NUCLEAR REGULATORY COMMISSION

Title: Advisory Committee on Reactor Safeguards

Date: Wednesday, September 3, 2025

Opening Remarks by the ACRS Chairman	4
Palisades Nuclear Plant Restart Activities . . .	7
Committee Deliberation on Palisades Nuclear Plant Restart Activities	62
Wrap-Up of Current ACRS Activities on the Seabrook Alkali-Silica Reaction Topic . . .	78
Committee Deliberation on Current ACRS Activities on the Seabrook Alkali-Silica Reactions	101
Adjourn

Figure 2.2: Schematic showing the effect of wall aspect ratio on predominant behavior and failure mode under lateral loading

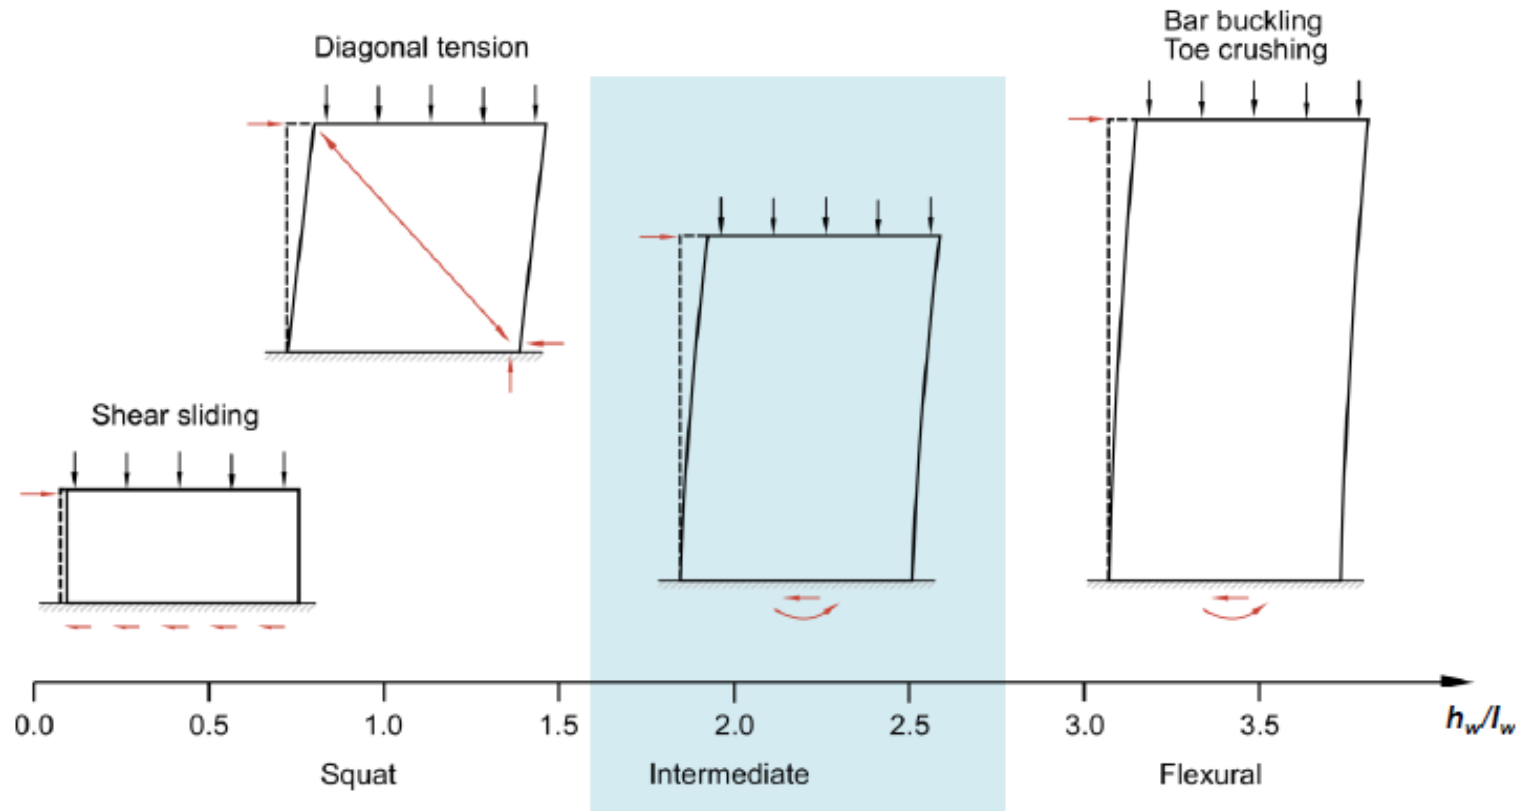
22 Now, moving the first area, which is the
23 limits of the test configuration and results to
24 Seabrook. This figure is a schematic. It's taken out
25 of the NIST report. It shows the effect of all aspect

1 ratios, which is height and length, and predominant
2 behavior and failure mode. The lateral loading
3 suggests (inaudible). And as we can see, as the
4 height of our aspect ratio moves from lower amounts,
5 lower value to higher, the dominant behavior tends
6 from shear to diagonal tension to flexure, and you may
7 have something intermediate in between. So our
8 technical and nuclear power plant shear walls aspect
9 ratio is one of the tests.

10 Now, in this test, ratio walls specimens
11 had a wall height to length ratio of two. And
12 therefore, (inaudible) and relatively low
13 reinforcement ratio, approximately .31 percent. And
14 the observed failure mode was in flexure or bending
15 and not in plane. As I mentioned --

Figure 1: Unanticipated pre-test delamination

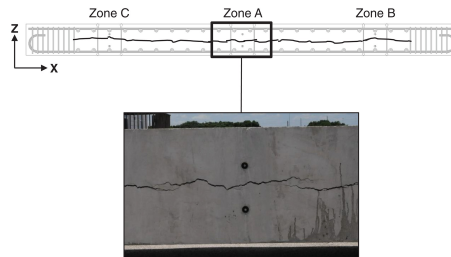
Turning to the LSTP tests, two distinct failures are evident:

Unintended: The absence of vertical reinforcement in the center of the beam allowed vertical expansion, producing a large delamination crack *before the test even started*. This flaw rendered all subsequent results highly questionable (Fig. 1).

Figure 2: LSTP specimen with shear and moment (flexure) diagrams

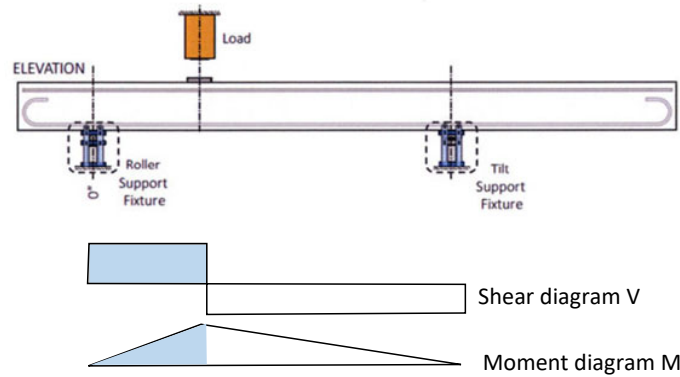
Intended: Since the purpose of the LSTP was to investigate the impact of AAR on shear strength degradation, the specimen should have been designed to maximize shear and minimize flexure. The NRC itself recognizes this necessity (see slide 4). However, even setting aside the pre-test delamination, the governing mode was not pure shear but rather *flexure-shear*². In the critical zone, significant shear was accompanied by a non-negligible moment—precisely the situation for shear walls with larger aspect ratios that the NRC criticizes in the NIST tests (Fig. 2).

Figure 3: LSTP vs. in-plane shear tests by others

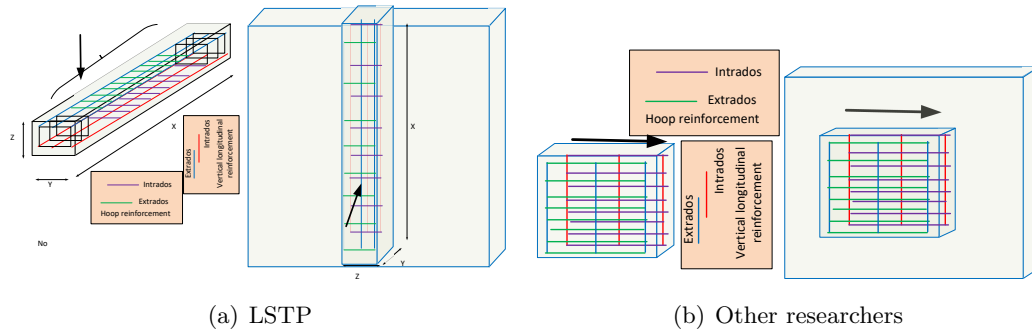
- By contrast, an **in-plane shear test** configuration, Fig. 3(b), would be far more representative of the structural response of an NPP containment under lateral seismic load. By limiting the height, flexural effects are minimized and shear clearly dominates.

Bottom line: to the best of my knowledge, the LSTP is the **only test program in the world** that relies on **out-of-plane shear** (Fig. 3(a)), in stark contrast to other researchers who correctly test **in-plane shear**.

This acceptance of LSTP by the NRC stands in direct contradiction to established principles of structural mechanics and to the testing practices followed worldwide.

Figure 4: Effect of underestimation of E_0 in expansion prediction

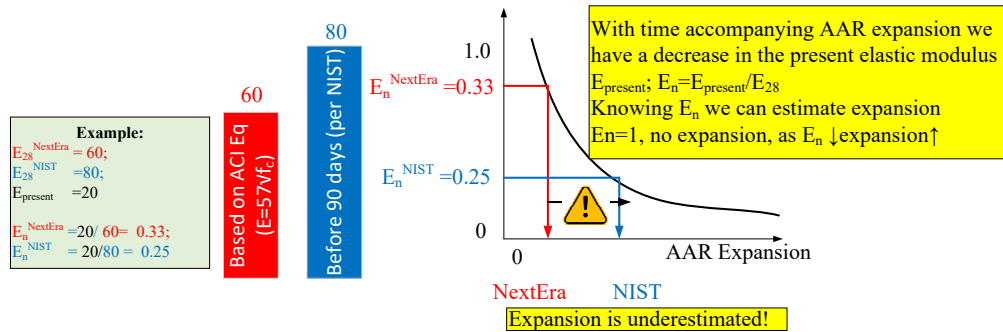
- **The NRC's first claim is categorically wrong.** The NRC states: “*In instances where the empirical modulus equation over-predicts the original elastic modulus, use of the modulus-expansion correlation adds conservatism to the approach.*” This is the exact opposite of reality⁹. As clearly shown in Figure 4, when the initial modulus is over-predicted ($E_0 \nearrow$), the normalized modulus decreases ($E_n \searrow$), which leads to **increased predicted expansion** ($\epsilon^{AAR} \nearrow$). This is **non-conservative**, not conservative.

- **The NRC made a blatant error in analyzing the impact of elastic modulus under-prediction.** Their claim that over-predicting the original elastic modulus “adds conservatism” is physically incorrect—it actually leads to non-conservative (higher) expansion estimates, as demonstrated in Figure 4.
